Post Drilling/Annual Well Site Inspection Form

| Section 1: General Information | |
|---|---|
| Well Name ML Investments #1-11, USWN 11-075-20025 | Area Office Boise / Director's |
| Authorized Contact: Dan Johaneck (208)707-7867 112 N. Plymouth, New Plymouth ID; Tyler Hartung (208) 412- 5475 | Inspection Date 9/29/2022 1:15 PM |

Well head and steel fencing looking southwest.

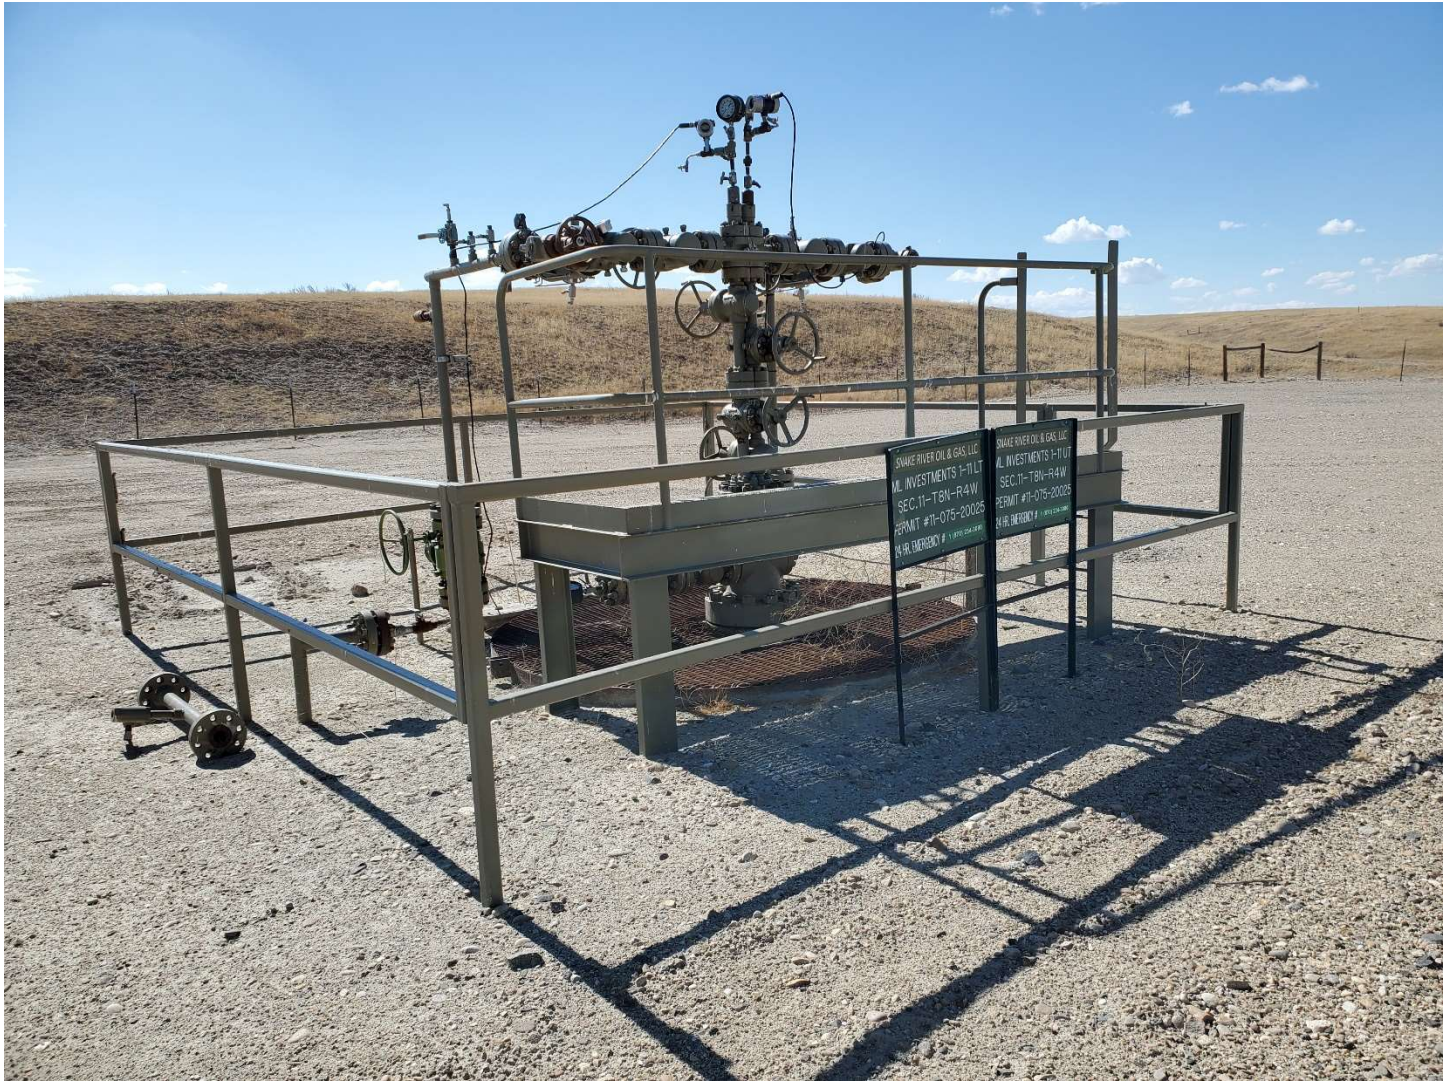
Surface casing: 0 psi

UT tubing string: 780 psi (analog)

LT tubing string: 0 psi (analog) – zone plugged

Well site clean, gate closed, no sign of animal / livestock activity on pad.
